PRODUCT CHANGE NOTICE

PCN#18-076

ZN2PD-02183-S+
ZN3PD-02183-S+
ZN4PD-02183-S+
ZN6PD-02183-S+
ZN8PD-02183-S+

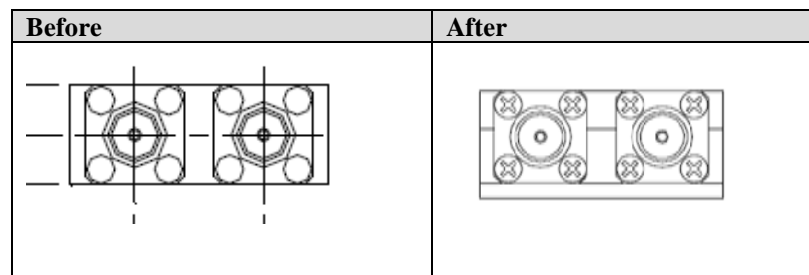
Change of FORM and FIT by addition of a plate to cover exposed screw heads

Change of FORM (appearance) and FIT (dimension) resulting from the addition of a 0.080" plate (see "After" image)

Cover for exposed screw heads on the case
